# Technical Updates for Pool Professionals

*May/2020*

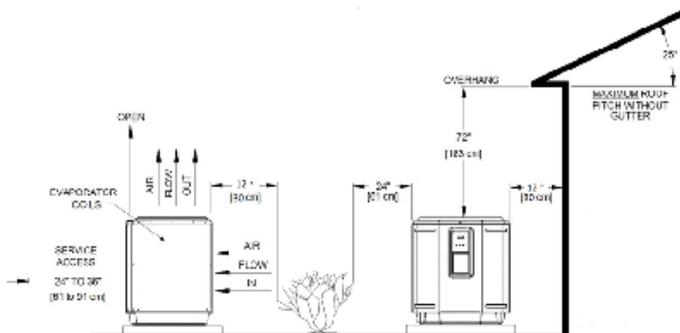
# A Change in Installation Clearances for Hayward Heat Pumps

Recent testing has shown that our heat pumps can be installed as close as 12" from an obstruction such as a wall or fence.

The letter shown here is available on the Totally Hayward website, and can be shared with builders and inspectors as needed.

**Figure2 Wiring Diagram**

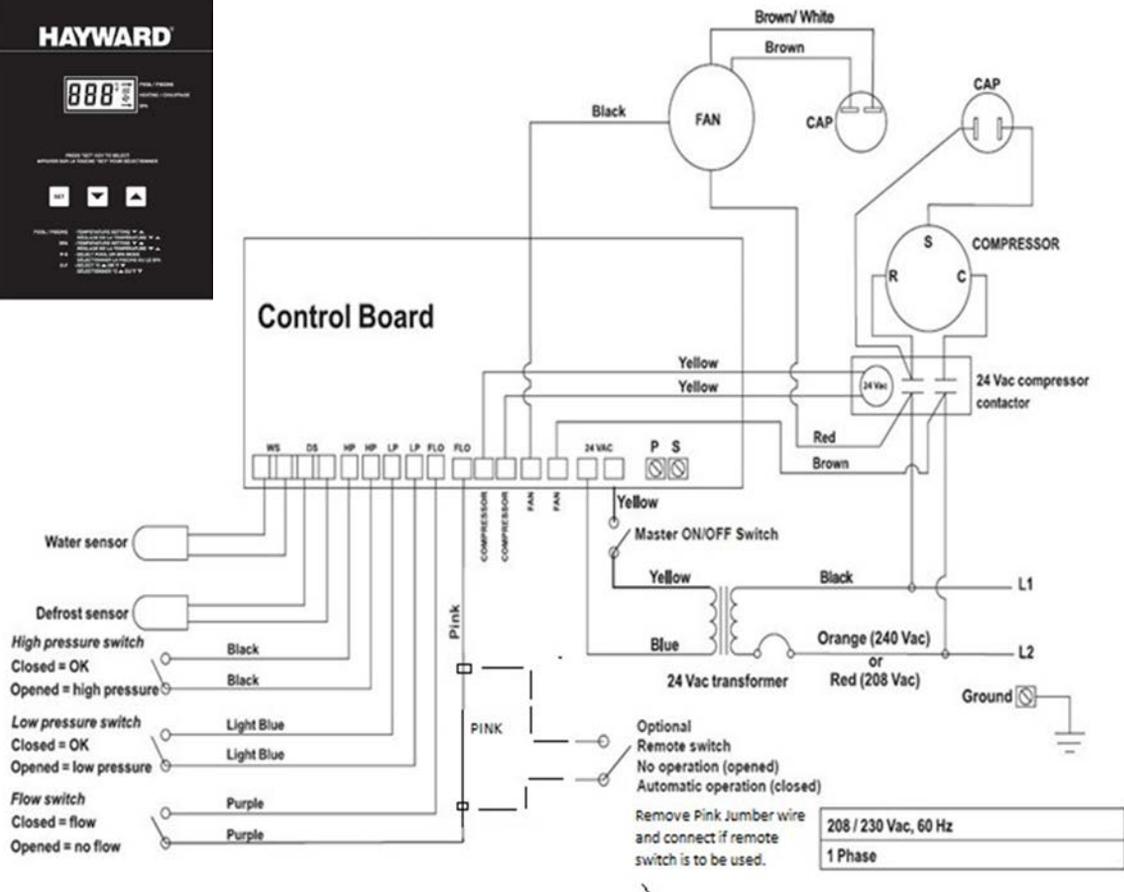
# A change in Automation Connections for Square Heat Pumps

Nashville built square heat pumps will have a different method for connecting to automation beginning with serial **#21132005103622001.**

• The terminal block that was mounted on the right exterior of the electrical panel has been replaced by a short pink jumper wire.

• To connect the heat pump to automation the jumper wire will be removed and the wires to the automation will attach where the jumper was removed

**Note change to the remote connection. Leave this diagram with this unit.**

1 To use the remote on/off connection, set Pool thermostat to off, set Spa thermostat to 104°F, set heat pump to Spa mode. Remove the pink jumper in the water flow switch circuit to the control board and connect the remote relay as shown in figure 12a. The code "FLO" will be displayed while remote circuit is open. The unit will wait for the remote contact to be closed to initiate the call for heat.
